UNITED STATES
NUCLEAR REGULATORY COMMISSION
REGION II
101 MARIETTA STREET, N.W.
ATLANTA, GEORGIA 30323

EXAMINATION REPORT - 50-302/92-300

Facility Name: Crystal River Nuclear Plant

Subject: Crystal River Unit 3
May 26, 1992 - NRC Initial License Exams

6 TURBINE BY-PASS CONTROL VALVES

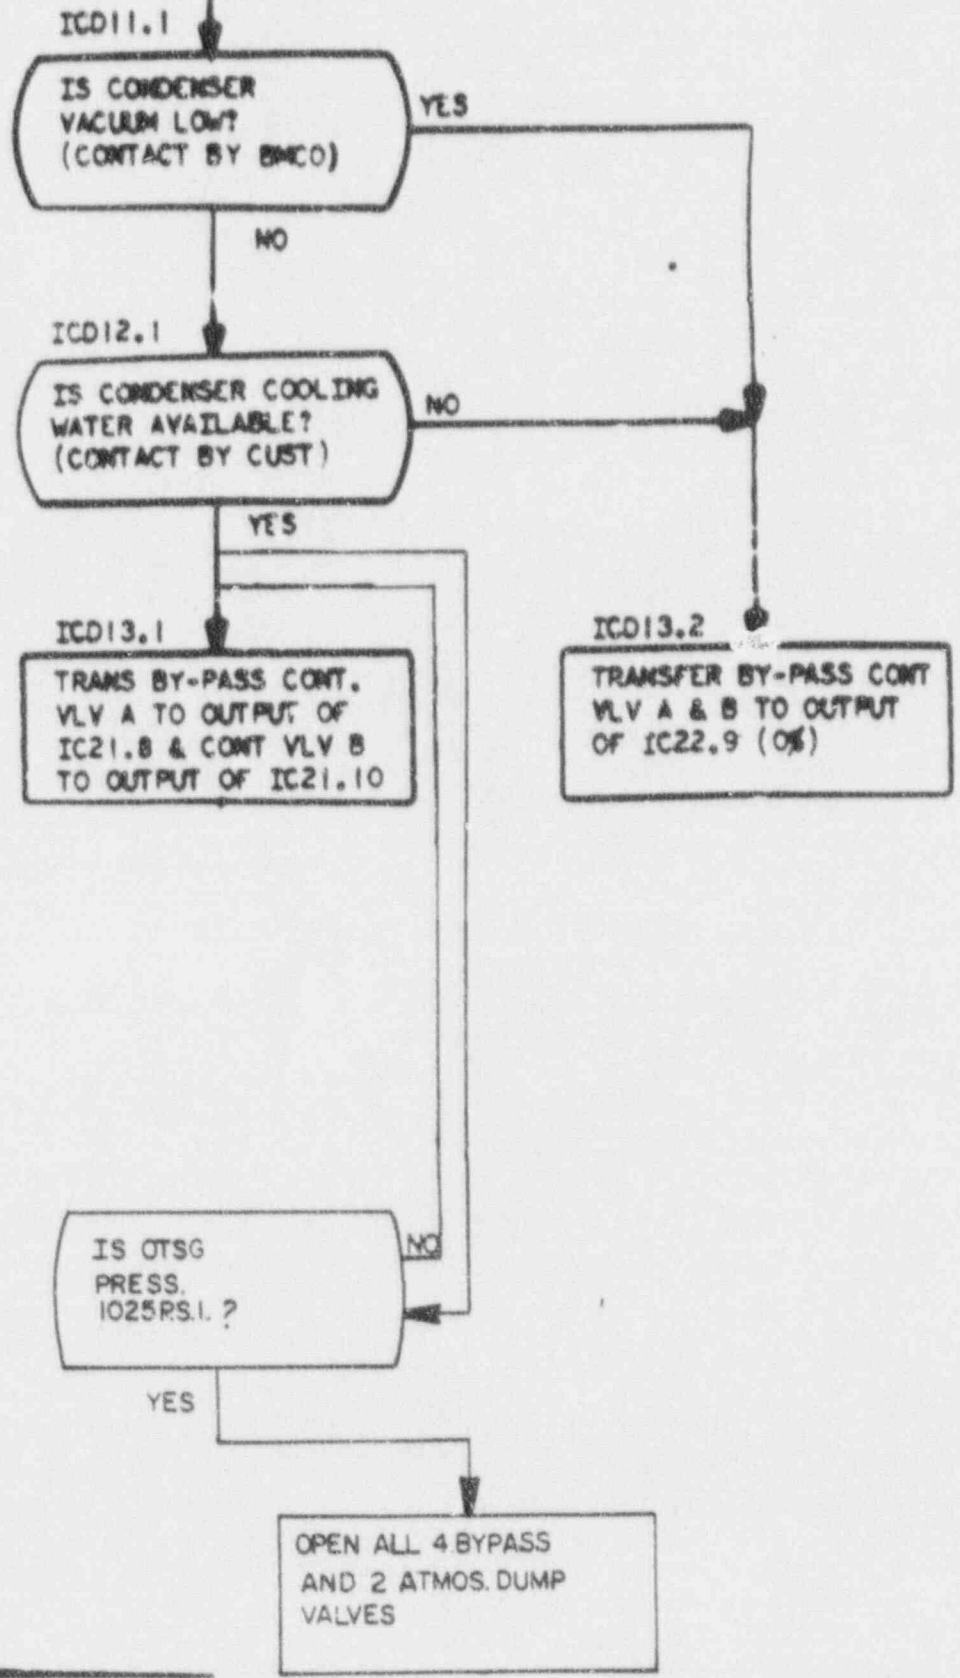
QUESTION: 055 (1.00)

The Integrated Control System (ICS) Turbine Bypass Valve (BPV) hand/auto station is in "Hand" with the bypass valves closed.

Which ONE of the following will fully open the bypass valves?

- a. Steam generator pressure is 1045 psig.
- b. Steam generator pressure is 1025 psig.
- c. Turbine header pressure is 1000 psig with a reactor trip.
- d. turbine header pressure is 875 psig with a turbine trip.

COMMENT

The purpose of the turbine bypass valve overpressure protection circuit is to open the valves when OTSG pressure exceeds a specific value (1025 psig). This is true of any relief valve. The pressure value at which the valve is fully open is not normally an operator concern once he has determined that the valve has opened at the correct value and is attempting to control pressure. The information used for this question is again information which was added to enhance the lesson plan and not intended as required knowledge. The objectives listed in this lesson plan and training provided to the operators have stressed the primary function of the valves to open at the setpoint of 1025 psig which corresponds to choice "B". As an additional consideration, the logic strings for the ICS show an additional circuit which will open the bypass valves fully at the 1025 psig setpoint (see attached). These logic drawings are given to the operators for training. Based on the above, it is reasonable to assume that an operator would select the 1025 setpoint as the full open value.

RECOMMENDATION

Accept answer "B" as correct.

4. Question 56 SRO: Comment accepted. The answer key will be changed to reflect that "b" is the only correct answer.
5. Question 69 SRO: Comment accepted. The answer key will be changed to reflect that "a" and "b" will be accepted as correct answers.
